ADDENDUM

Project: BSDC - Central Heating Plant Upgrades

Project No.: 11037-178
Addendum No.: 3
CC:

FIRST FLOOR ELECTRICAL PLAN

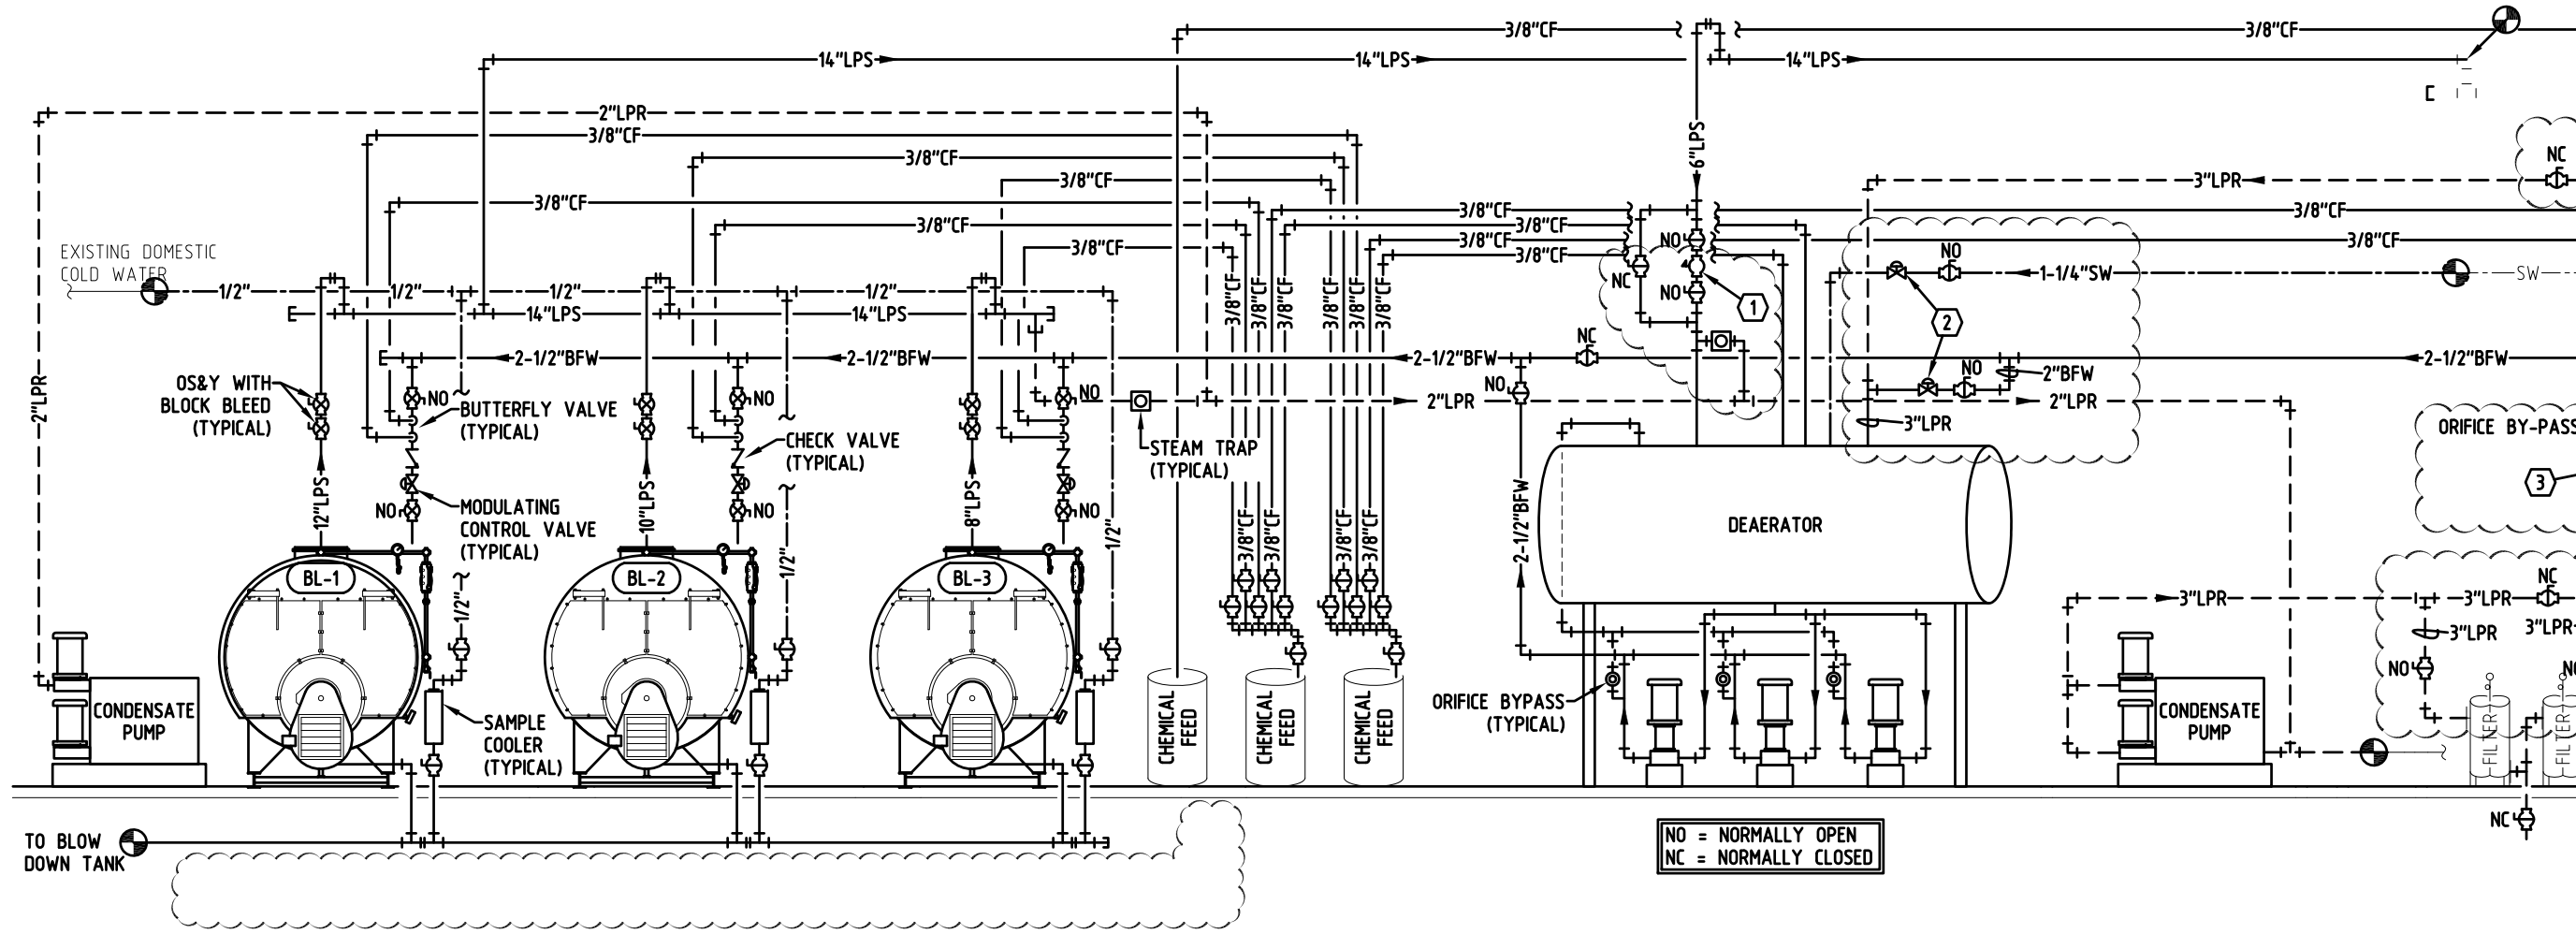
A. First Floor Electrical Plan

- 1) Add keynote 13; 'Furnish/install new emergency combination exit/egress light fixture w/remote lamp head; mftr: Lithonia LHQM S W R 120 HO/ELA T NX H0606 [or equal]. Connect to local unswitched circuit. See attached drawing ADD03.25E10.1 for locations.
- 2) Add keynote 14; 'Furnish/install new emergency combination exit/egress light fixture; mftr: Lithonia LHQM S W R 120 N [or equal]. Connect to local unswitched circuit. See attached drawing ADD03.25E10.1 for locations.
- 3) Add keynote 15; 'Furnish/install emergency lighting unit w/mounting shelf; mftr: Lithonia ELT24 N ELA MST [or equal]. Mount @8'-0" AFF. Connect to local unswitched circuit. See attached drawing ADD03.25E10.1 for locations.

D 1 BOILER PIPING SCHEMATIC
 25M2.0 SCALE: NONE

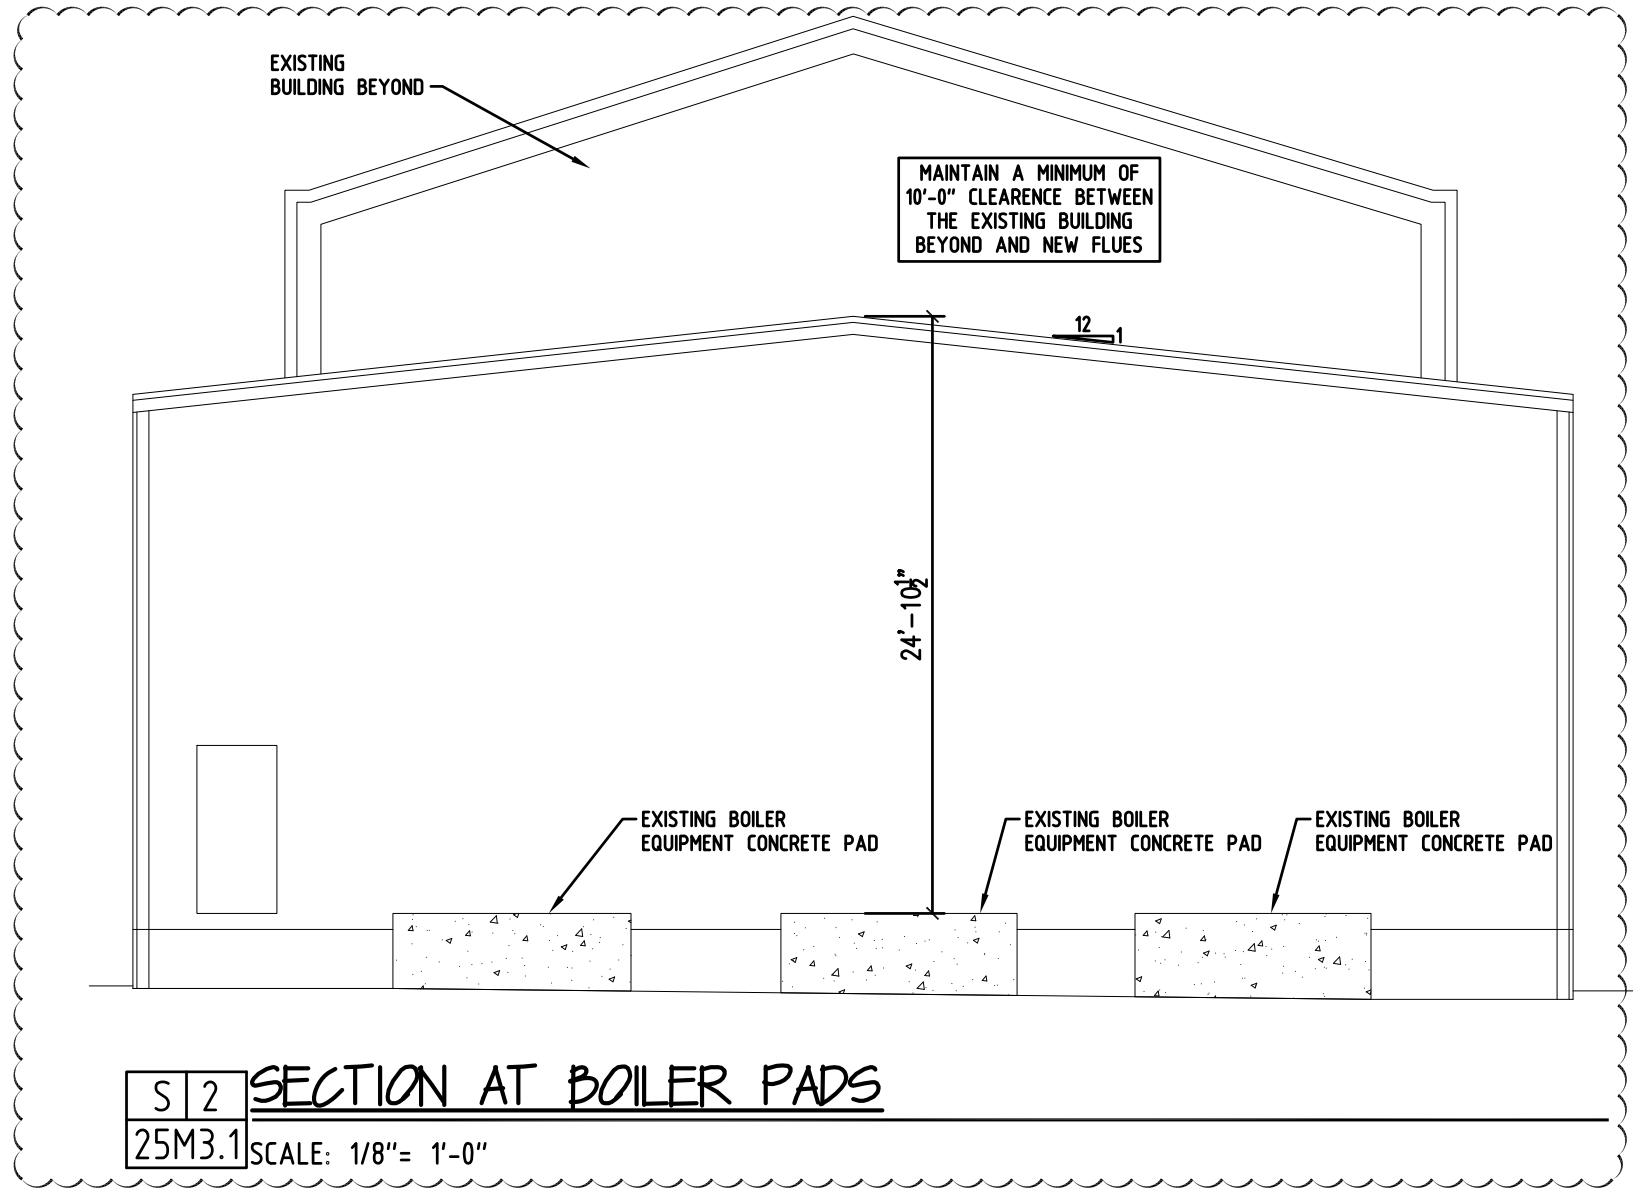
A. Boiler Piping Schematic-ADD02.25M20-1

- 1) A demolition layer was mistakenly left on; refer to attached revised schematic ADD03.25M20-1. Refer to ADD02.25M20-2 for continuation of schematic.

ADDENDUM: ADD03.25M31-1

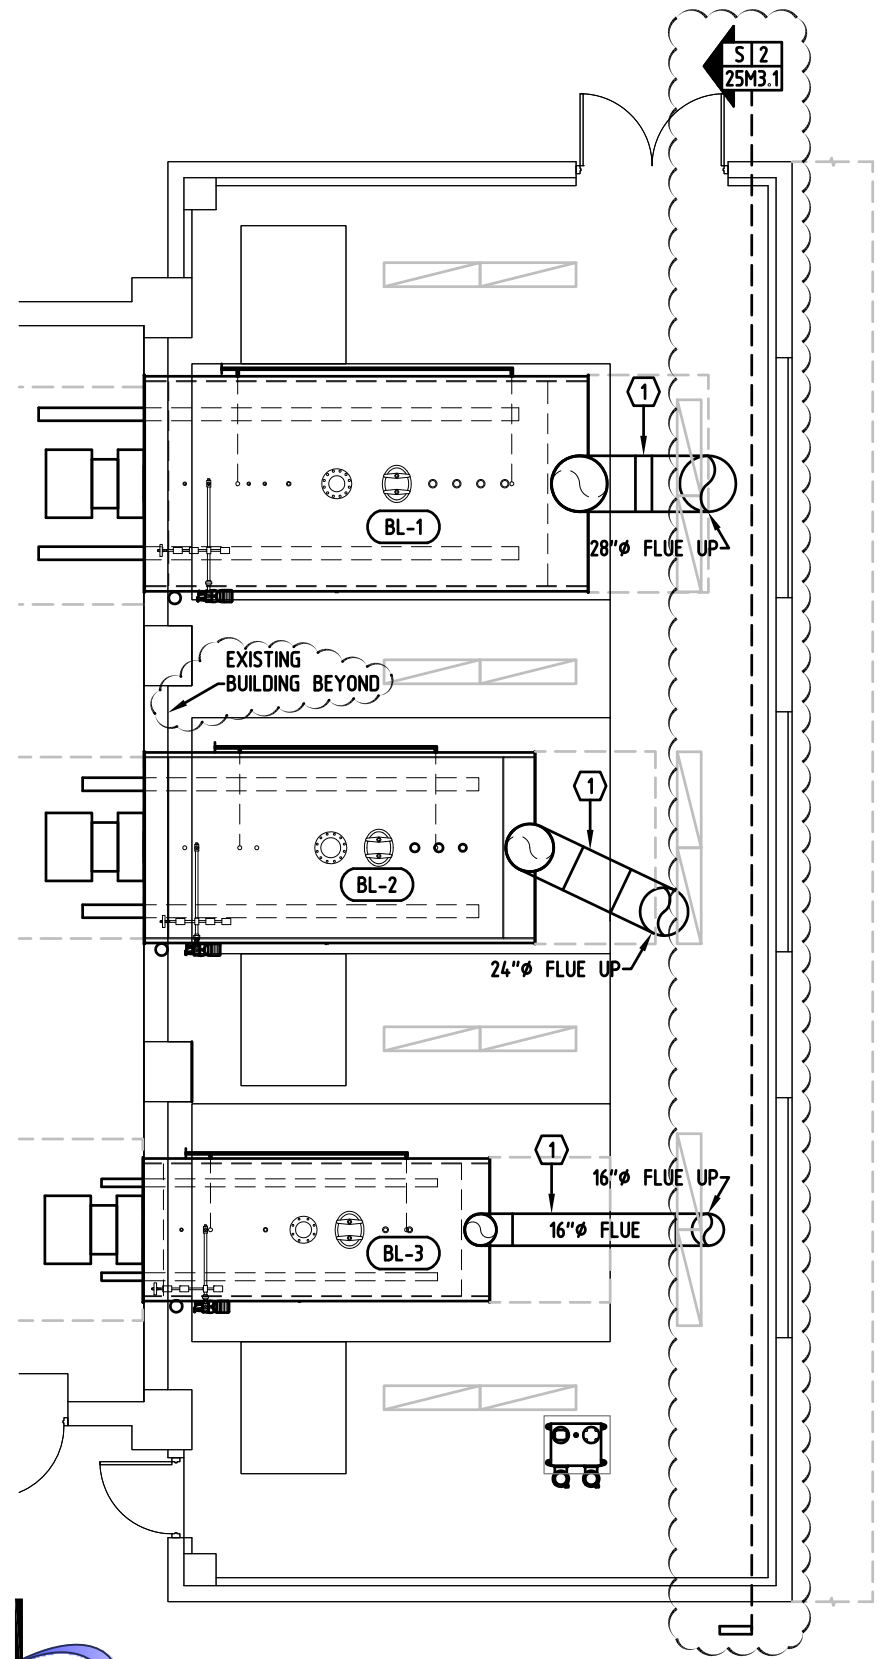
A. HVAC Plan

- 1) See attached drawing ADD03.25M31-1 showing an elevation of the boiler roof.
- 2) Key note shall read "Cut round opening in duct and provide crimped collar, provide size of opening as shown on plans."

PIPE MATERIAL AND INSULATION

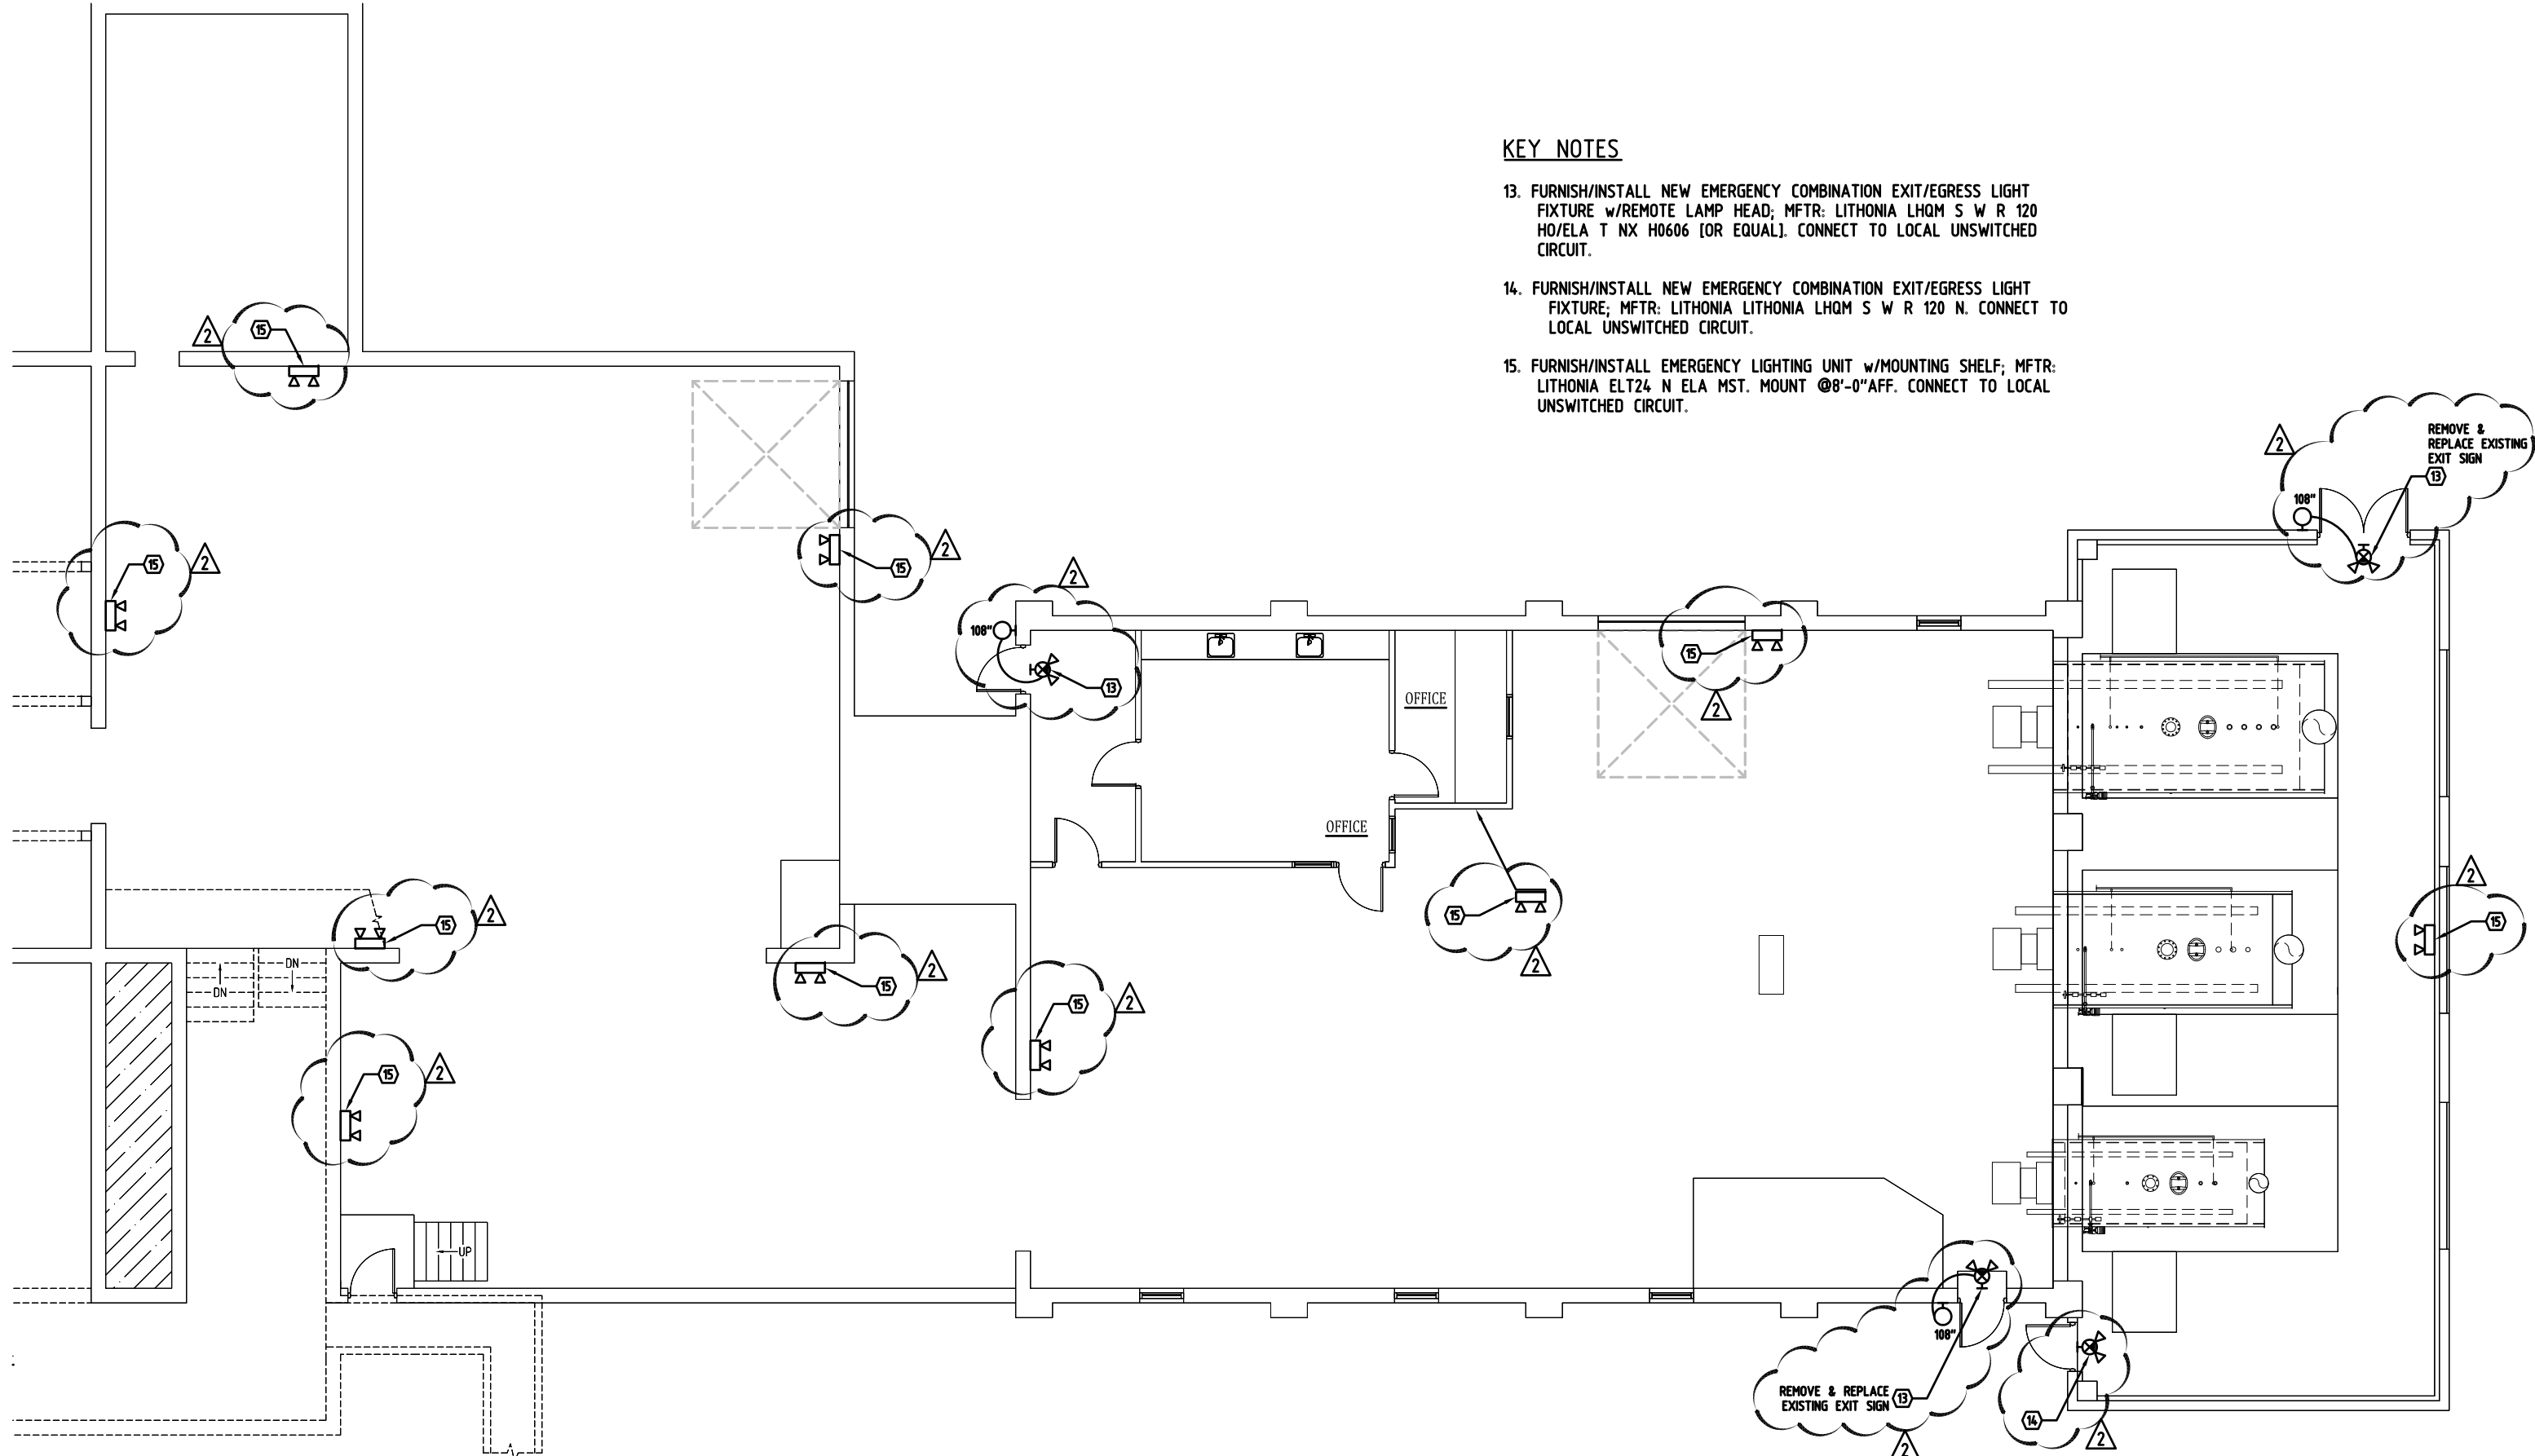
A. Piping Material and Insulation Schedule

- 1) Revision to steam condensate piping 3/4" and smaller shall be schedule 80 black steel. Refer to attached sheet ADD03.M51-1.
- 2) Added boiler feed water piping to schedule. Refer to attached sheet ADD03.M51-1.
- 3) Added rain water piping to schedule. Refer to attached sheet ADD03.M51-1.
